<i>NCSX RFD</i> <i>Part I</i>	Number: 14-004	RFD Description: Add fillets to Modular Coil Lower Lead Blocks to aid machining
Initiator: John Puhl		Organization: JP Pattern
List of Impacted Documents: (<i>Specification, MIT/QA Plan, SOW, drawing, etc.</i>) Drawing: SE142C-134-r0 Drawing: SE142C-135-r0		
Cost Impact: (<i>If none, so state</i>) NONE		
Schedule Impact: (<i>If none, so state</i>) NONE		
Quality Impact: (<i>If none, so state</i>) NONE		
State Requirement Deviation is Requested For: (<i>Specification, MIT/QA Plan, SOW, drawing, etc.</i>) Drawing: SE142C-134-r0 Drawing: SE142C-135-r0		
Full Description of the Deviation Requested: (<i>Use continuation pages, e-mails, letter, sketches, etc. as needed and include amplifying information as appropriate to support deviation request.</i>) The following changes are requested to to aid in machining (see attached sketches). <ul style="list-style-type: none"> • <u>C02a fillet-n-rnds se142c-134-r0</u> • 1/16 fillet added to posts due to surface not being planar. Is this acceptable? If not area could be filed out.(red) • 1/16 fillet added to inner rib.(red) • 1/64 round added due to area being extremely thin. (Cyan) • 1/32 round added

Attachment [1]
c02a_fillet-n-rnds_se142c-134-r0.gif

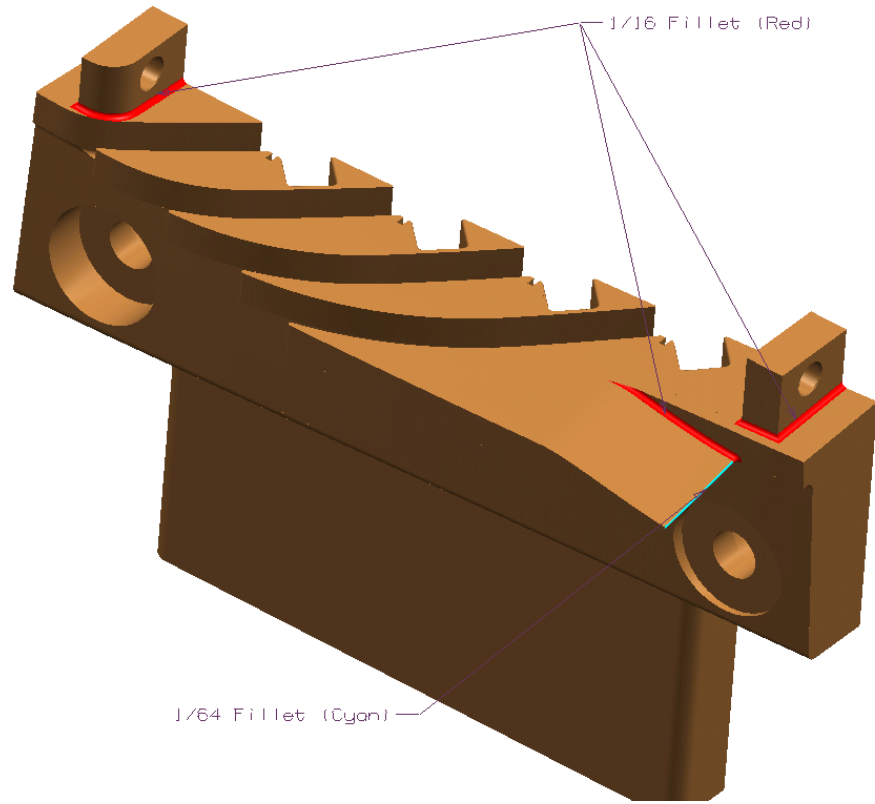
* C02a_fillet-n-rnds_se142c-134-r0

* 1/16 fillet added to posts due to surface not being planar. Is this acceptable? If not area could be filed out.(red)
* 1/16 fillet added to inner rib.(red)
* 1/64 round added due to area being extremely thin.

(Cyan)

* 1/32 round added to ribs due to area being thin also
(yellow)
